Interactive comment on “Hydraulic modelling of drinking water treatment plant operations” by G. I. M. Worm et al.

G. I. M. Worm et al.

Received and published: 16 December 2008

Fig. 2.

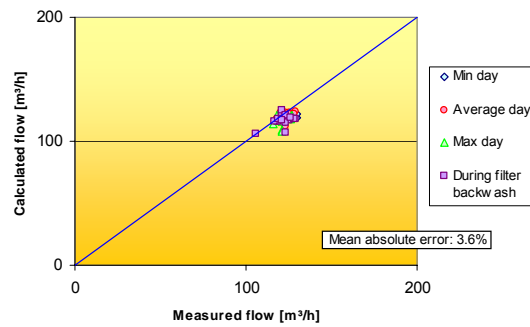
Q: The graph of validation accuracy reports a commendably low MAE of 3.6%; but by eye data match is poor.

A: The poor eye data match in comparison to the other results are caused, most prob-

ably, to the different scales used. The scales have been equalled, yielding updated Fig 2, 4 and 5.

Fig. 5.

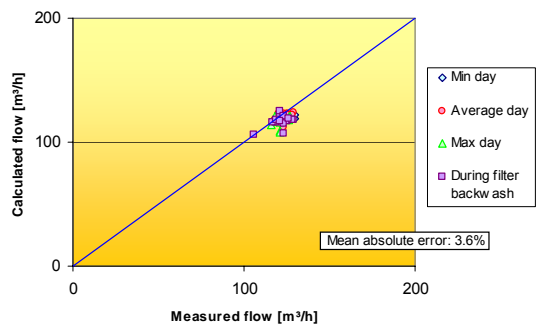
Q: The other processes look to be a better fit, but with the sand filters having the calculated flow consistently greater than the measured flow.

A: The referee mentions the sand filters have the calculated flow consistently greater than the measured flow. This was further analysed by the authors. Obviously the pumps deliver more water than would be expected. Authors consider it's likely the formula used to calculate the pump speed (technical specification current frequency controller) is not accurate. For the percentage of the speed control 0% equals an electricity frequency of 13 Hz in stead of 15 Hz and 100% equals an electricity frequency of 56 in stead of 58 Hz. As can be seen in Figure 5 model results are more balanced and have a higher accuracy as well.
